Planning Responses

Re: West Yard, Camden Lock Market, London, NW1 8AF

Installation of 34 temporary market stalls (A5 Use) in the West Yard of Camden Lock Market.

01

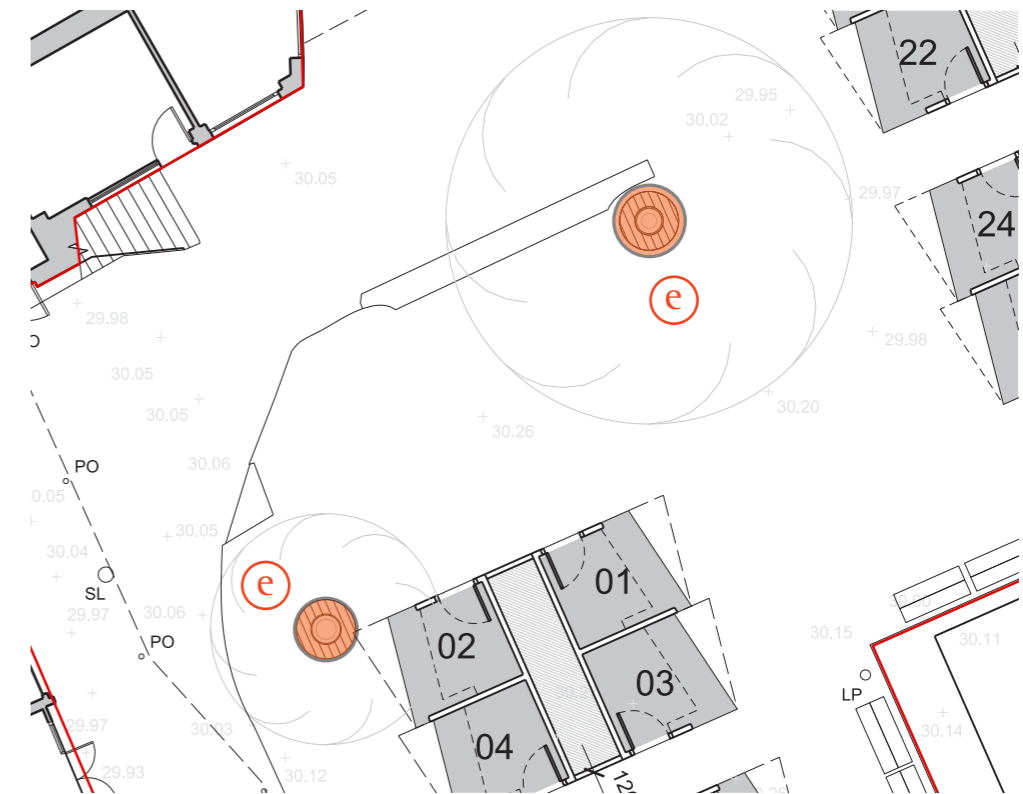
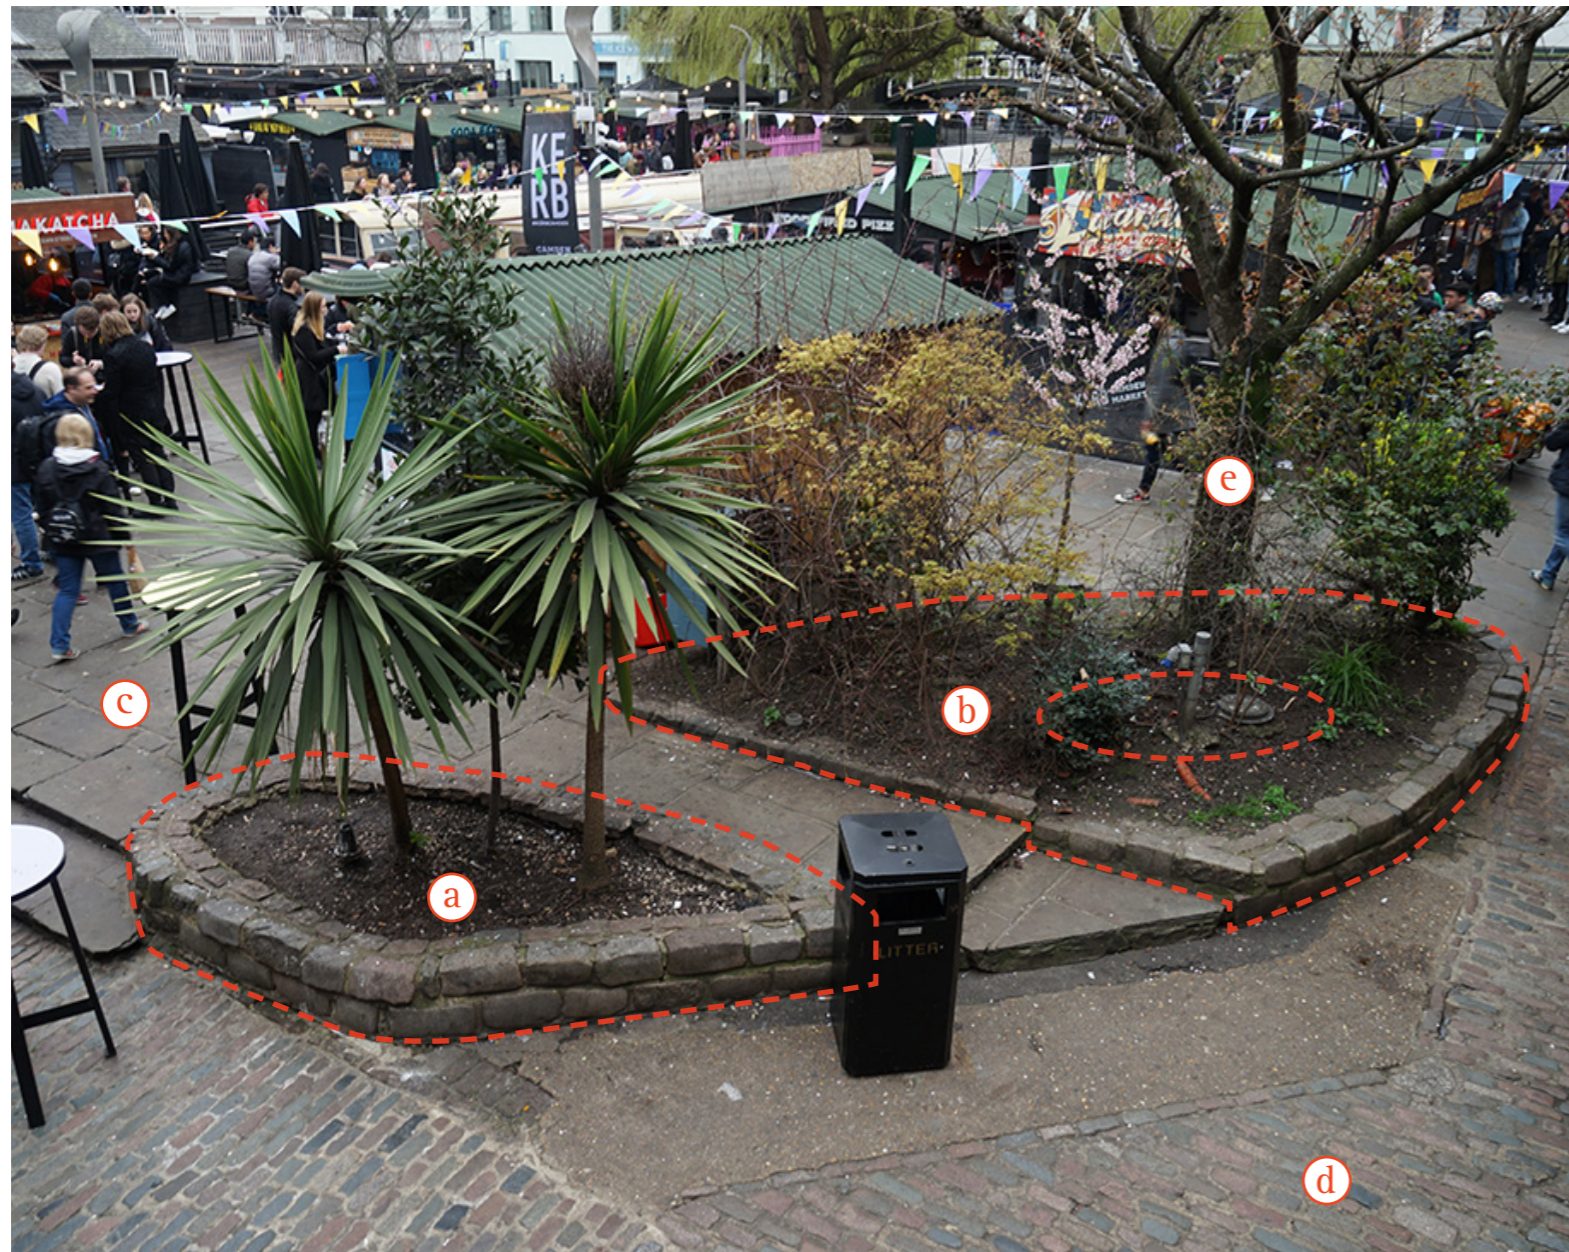
I have concerns regarding replacing the planters with cobbles. Whilst removing the planters to increase circulation space is a good idea, the surface material needs to be accessible and inclusive and cobbles do not meet this requirement. It would be nice if consideration was given to providing some accessible seating in lieu of planters.

We feel it is vital to open up the areas around the planters to enhance circulation space. Therefore we propose to replace the planters (a/b) with paving slabs as per the central part of West Yard (c), rather than cobbles which currently surround it (d). The proposals retain the protected trees (e), and planters will remain around the base of the tree. The paving slabs will offer a similar level of accessibility and aesthetics, when compared with the surrounding pavers towards the centre of the market.

Plan of 4x proposed stalls

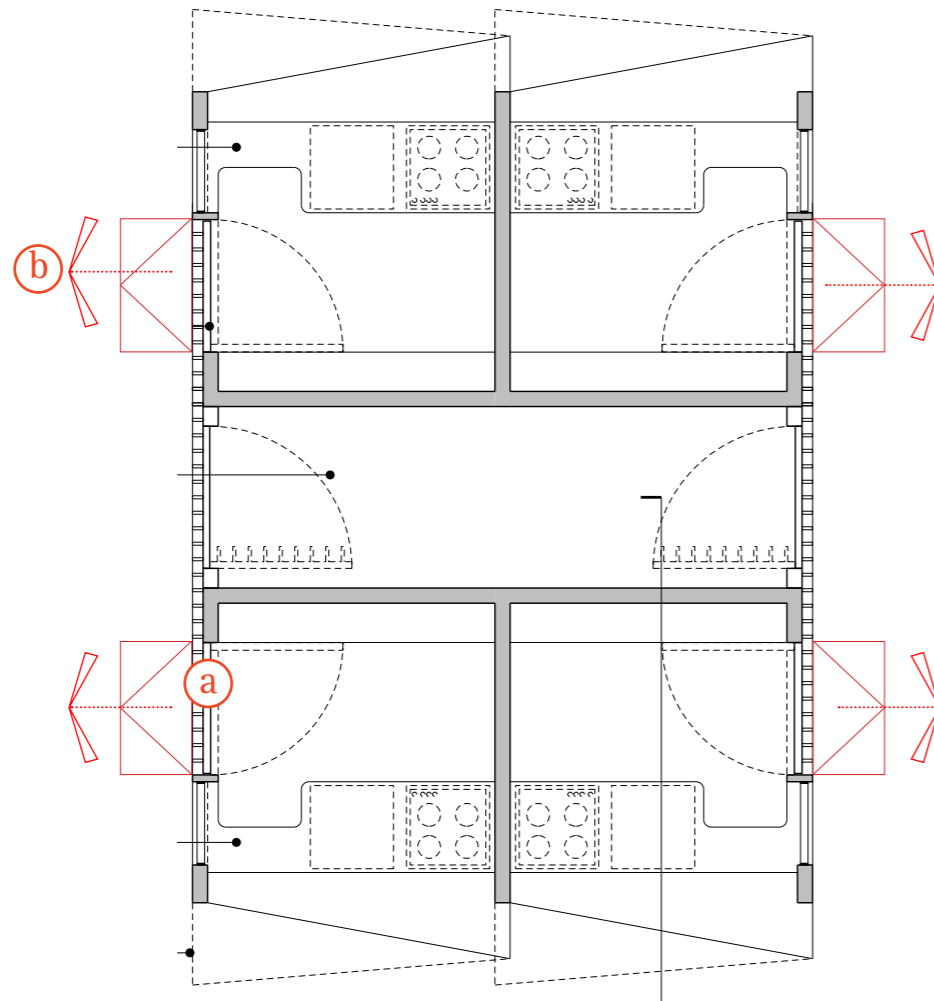
The access statement does not cover access to the units for staff or customers who may have a disability. It should be updated to cover these issues. How is level access to the units being provided? The serving counter seems too high for use by those of short stature or wheelchair and scooter users. Is an induction loop available at the counters to meet the needs of those with hearing impairments?

The nature of the temporary structures results in the internal floor level to be raised from the ground. Access to units can however be provided by temporary ramps (a). The raised floor also has benefits of improved Health & Safety and Hygiene, providing enhanced protection against vermin over the existing stalls.

Service to customers in wheelchairs or accessibility scooters can be via the access door to the side of the unit, as the current arrangements in the existing market stalls (b). Lowering the countertop heights will compromise space for under-counter appliances required by most traders.
